RESOLUTION AFFIRMING THE DECISION OF THE HISTORIC PRESERVATION COMMISSION TO CONDITIONALLY APPROVE A CERTIFICATE OF APPROPRIATENESS FOR THE REPLACEMENT OF TEN WINDOWS IN THE MULTIPLE-FAMILY DWELLING AT 826 18TH STREET

RE: Conlin Properties/826 18th Street in Sherman Hill

**RE: APPEAL FROM DECEMBER 5, 2011 HISTORIC PRESERVATION
COMMISSION RULING CERTIFICATE OF APPROPRIATENESS;
CASE NUMBER 20-2012-5.14**

826 18th Street – Photograph Prior to Work – Polk Co Assessor 1/24/2004

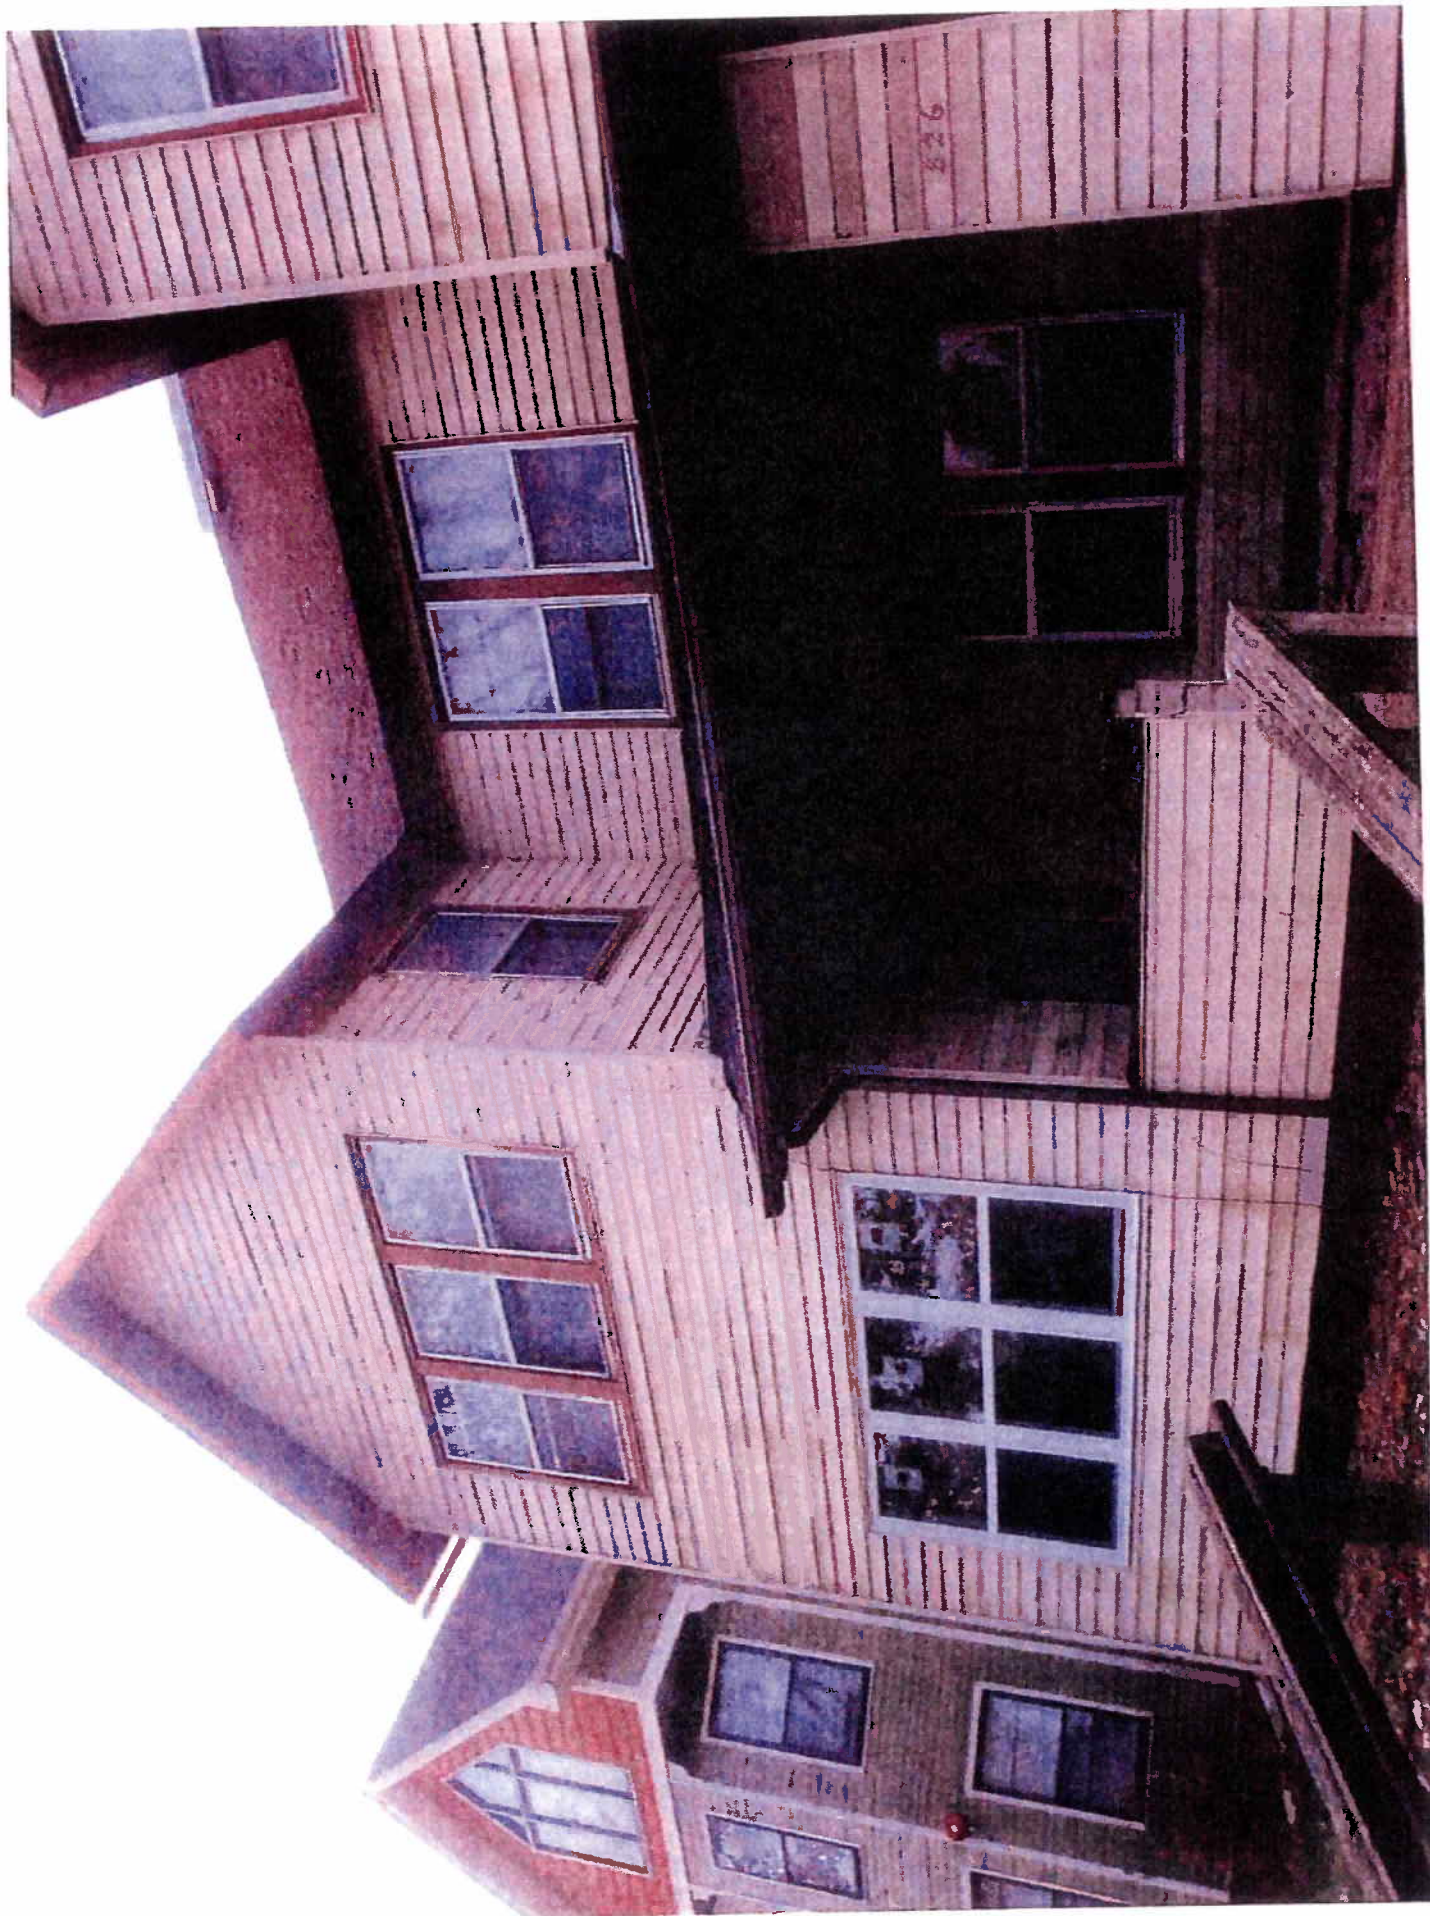
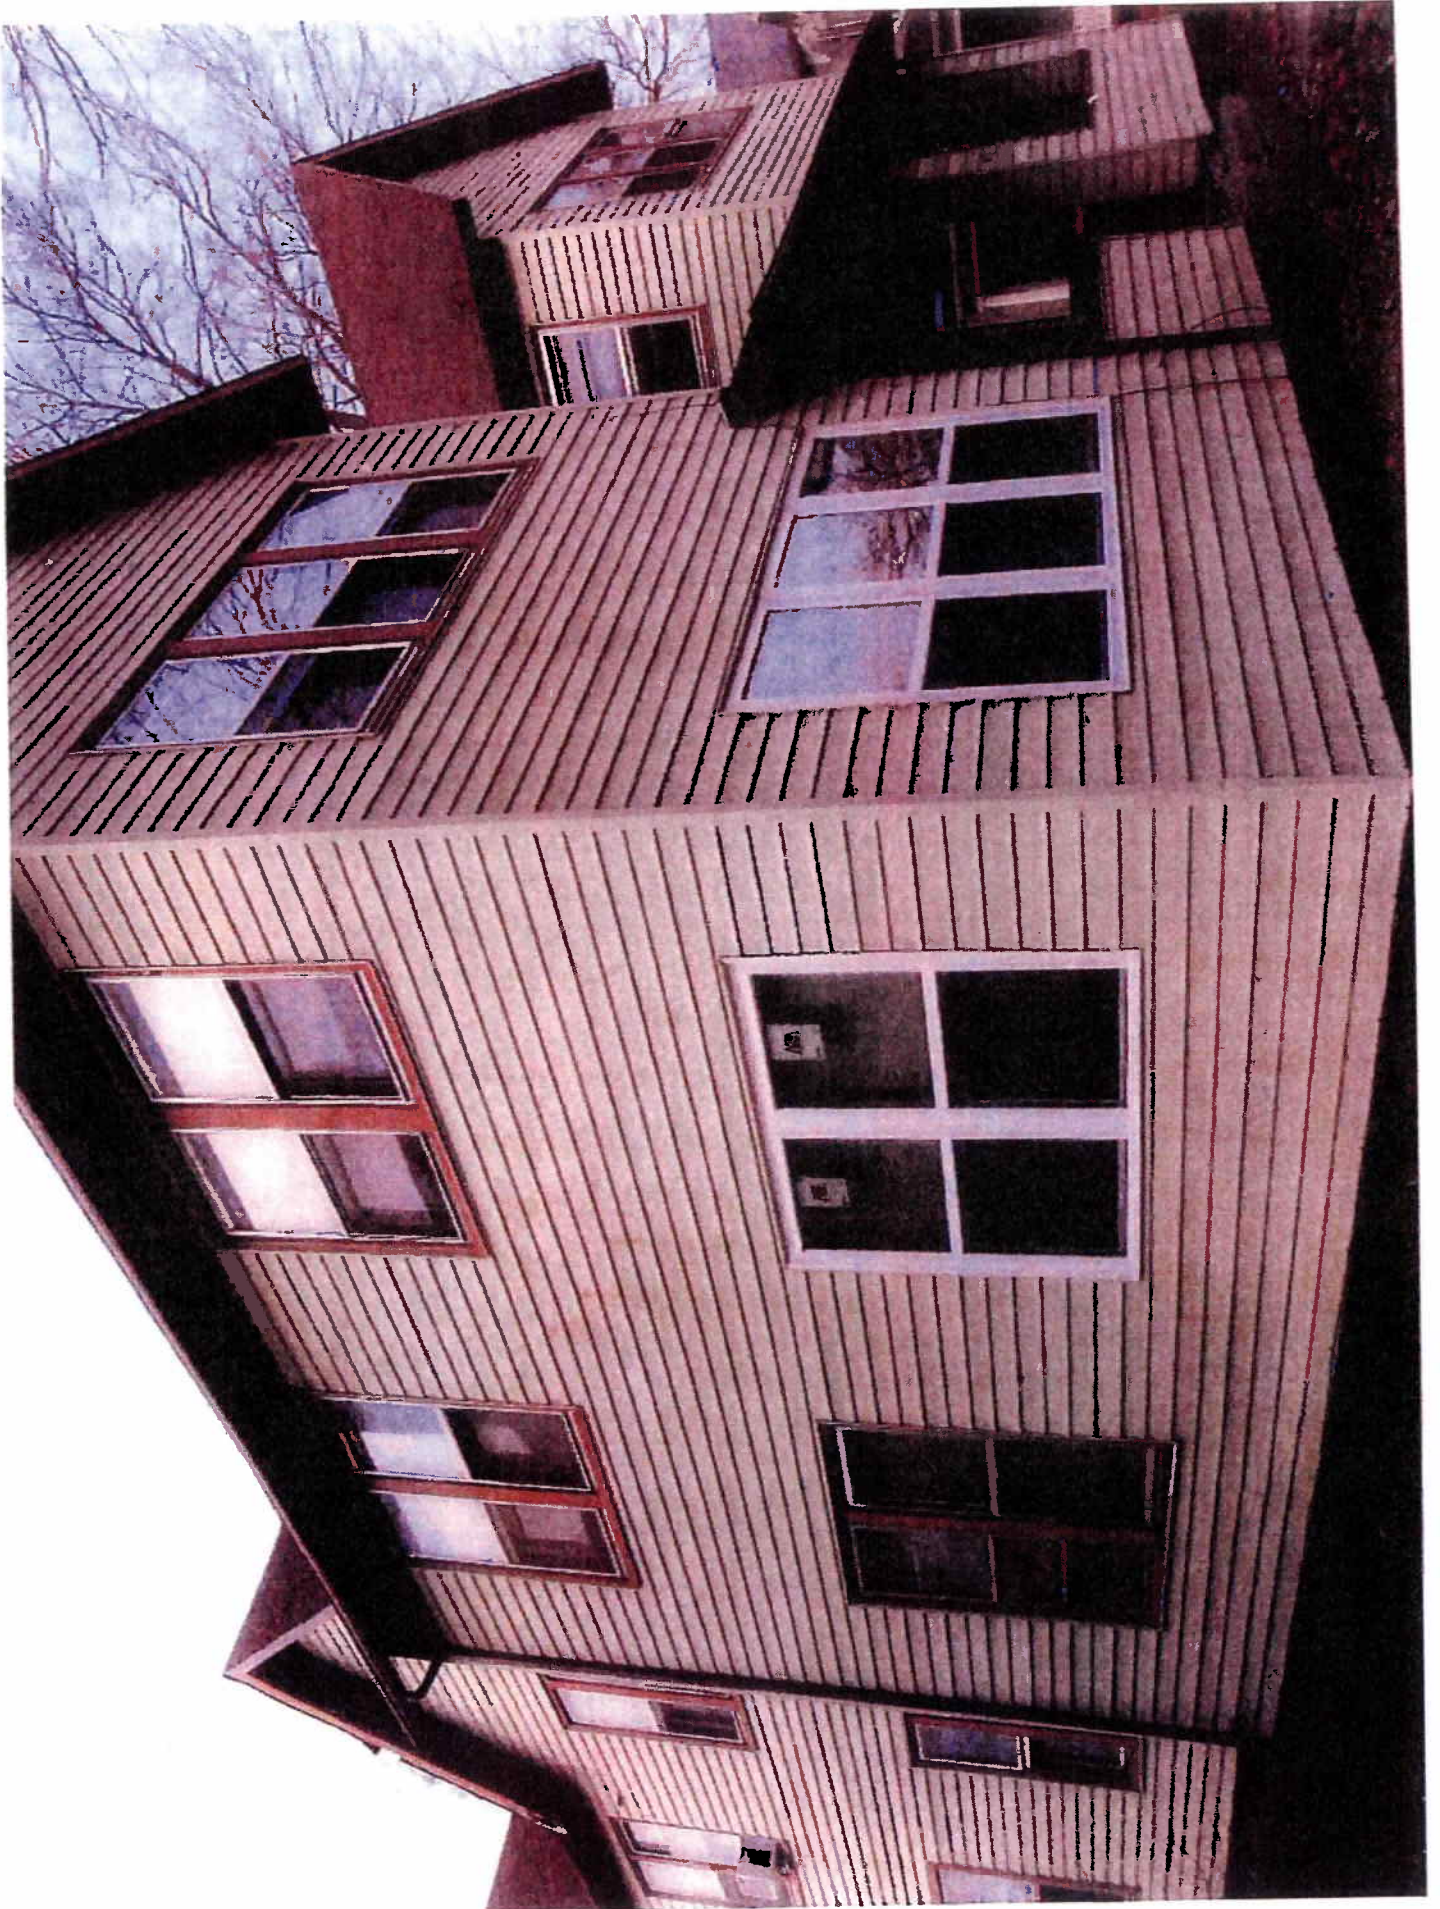
The applicant is proposing to replace 10 first floor apartment windows including the 6 southernmost windows on the front facade and the 4 easternmost windows on the south facade. Five of these windows were replaced with a vinyl window product before a stop work order was issued. The applicant wishes to retain these windows and to replace the remaining windows with the same vinyl product.

The proposed vinyl windows do not comply with the design guidelines, specifically guideline "b" listed above, which states replacement windows should duplicate the original windows in type, size, and material. The Commission has consistently required the use of wood windows when replacement has been approved including the applicant's property at 677 16th Street in 2006. During the past 12 months the Commission has reviewed 8 cases similar to this request and required the applicant to repair the windows and/or replace them with wood windows. Staff recommends approval of replacing the 10 windows subject to the windows being constructed of wood with no cladding.

1. The windows shall be constructed of wood with no metal cladding.
2. The windows shall be of the same general style, shape and dimensions as the existing windows.
3. Review and approval of the selected window product by staff prior to installation.
